DESCRIPTIVE REPORT

Registry No. H-10985

General Locality Icy Bay

Sublocality Point Riou Spit

Figure 1. H10985 Survey Limits

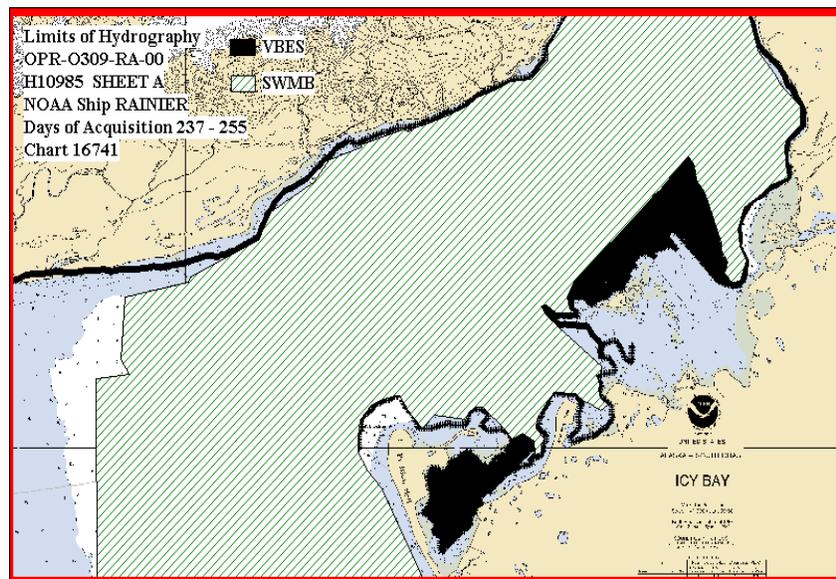
This hydrographic survey was completed as specified by Hydrographic Survey Letter Instructions OPR-O309-RA-00, dated August 10, 2000, and the Draft Standing Project Instructions dated April 6, 1998. The purpose of this project is to provide contemporary hydrography with full-bottom multibeam coverage in a portion of Icy Bay and Riou Bay, Alaska. This project responds to requests from the Southeast Stevedoring Corporation, Alaska Board of Marine Pilots and Southwest Alaska Pilots Association. It addresses concerns for the safety of increased commercial traffic in the area and approaches surrounding Point Riou Spit and Moraine Island in Icy Bay, Alaska. The survey specifically addresses concerns of shoaling in Riou Bay and areas surrounding the inner anchorage. The survey's northern limit is latitude 60°01'20"N and the southern limit is latitude 59°53'04"N. The survey's western limit is longitude 141°40'33"W and the eastern limit is longitude 141°14'18"W.¹

¹ PHB Revision –The survey limits should be; northern limit is latitude 60/01/23N, southern limit is latitude 59/52/40N and the eastern limits is longitude 141/15/41W and the western limit is longitude 141/40/35.5W. Depths range from zero to sixty fathoms.

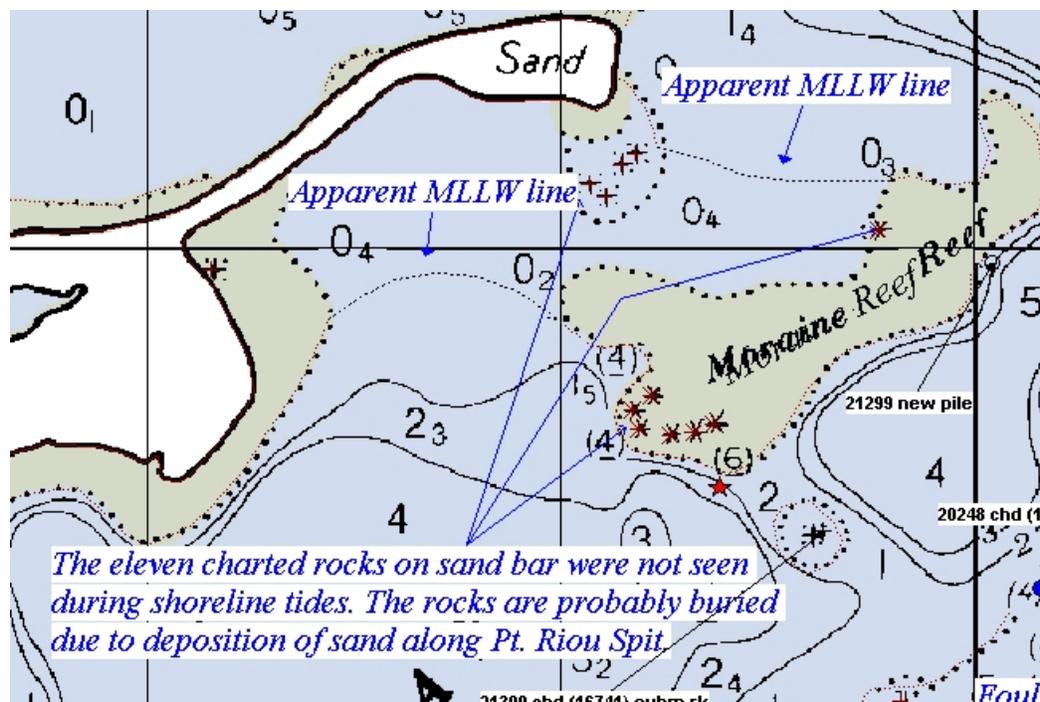
Significant changes to the shoreline and several new features were discovered during shoreline investigation and SWMB and VBES hydrography. Point Riou Spit has migrated west and north up to eight hundred meters, resulting in a significant change to the Mean High Water line. Significant shoaling was also found near the Caetani River mouth. Most of the charted rocks on Point Riou Spit and Moraine Reef were not found during low water, as the reef is now largely covered with sand and has grown larger. Many charted features were unreachable with a survey launch even during mid to high tides, particularly in the vicinity of Gull Island. In many instances, DPs were taken from the nearest possible location when feature were deemed significant to navigation. These rocks are noted as such, in blue on the DP and BS Plot, and the Hydrographer, unless otherwise noted, recommends retaining them as charted.²²

Much of the shoal area east and south of Gull Island now exposes at Mean Lower-Low Water (MLLW). An approximate MLLW line based on field observations during times of low water is depicted on the DP and BS Plot. The Hydrographer recommends revising the charted MLLW line to an approximate line as depicted in the vicinity of the Caetani River, as well as the region east and west of Gull Island.²³

²² PHB Revision – Detached positions and shoreline information provided by the hydrographer was evaluated during office processing and shown on the smooth sheet as warranted.

²³ PHB Revision – Chart these approximate zero depth contours as depicted on the smooth sheet.
